MITSUBISHI FUSO
TRUCK OF AMERICA, Inc.

05F-077

**Subject: Mitsubishi Fuso Truck & Bus Corporation Foreign Recall Notification
(Substantially Similar Vehicle)**

2. Identification of Vehicles/Production Period:

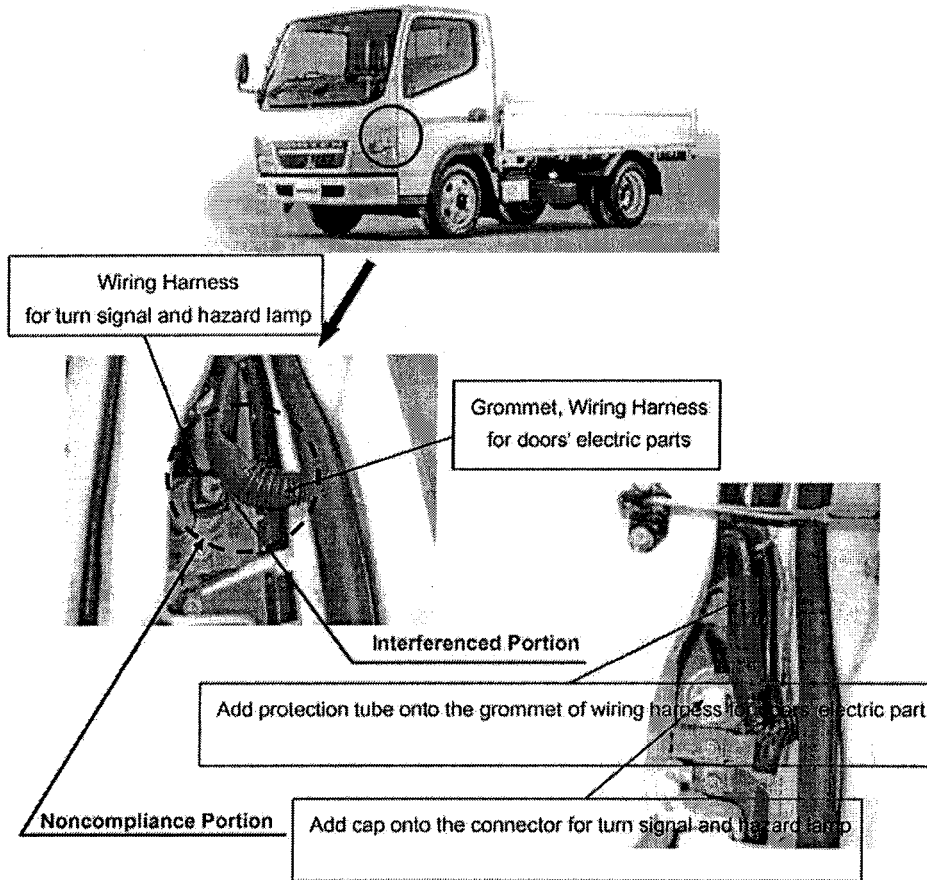
The door wiring harness interferes with the turn signal and hazard lamp wiring harness due to improper routing. Repeated opening and closing of the doors could break the turn signal and hazard lamp wiring harness, causing the lamps to become inoperative.

Add protective tubing at the door wiring harness grommet, install a protective cap on the turn signal and hazard lamp connector and repair any wiring harness damage.
